Submission

MONTPELIER DEVELOPMENT ASSOCIATION,

Project 17101-001 Brookhaven, Montpelier, Co. Limerick

Report on the Wastewater Treatment Plant

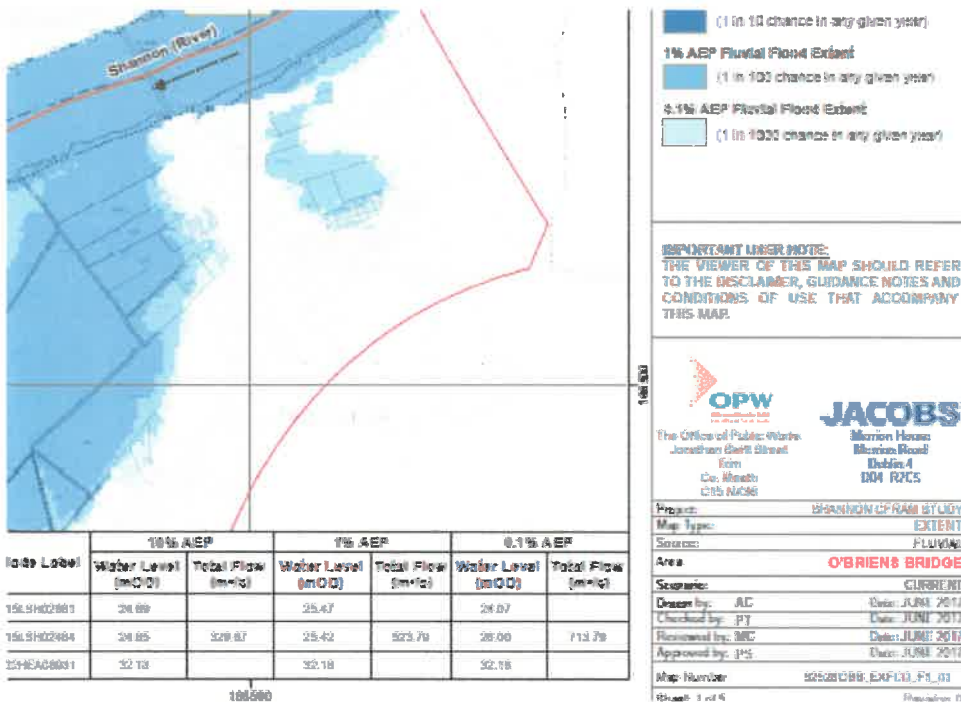
On the proposal in Environmental & Heritage Considerations and in the planning report, it appears as if an outdated CFRAMS map dated July 2016 has been included. We attach link to June 2017 report¹ which clearly shows that the location of the existing septic tank in the area is located in a 1% AEP area that we know has been flooded in the past – see below and attached picture of local flooding. This was not shown on the July 2016 version so are concerned that non-current information has been used in assessing the feasibility and impact of this development. Furthermore as per picture, it is clear that part of the development site was affected during the November 2009 floods.

The objectives of the guidelines for local Authorities in The Planning System and Flood Risk Managementⁱⁱ are to avoid new developments increasing flood risk elsewhere, including that which may arise from surface water run-off². The site proposed for development is very steep and a number of properties ground level will be substantially higher than adjoining existing properties. We feel more details and assurances are required in ensuring no adverse impacts on existing properties as a result of this development.
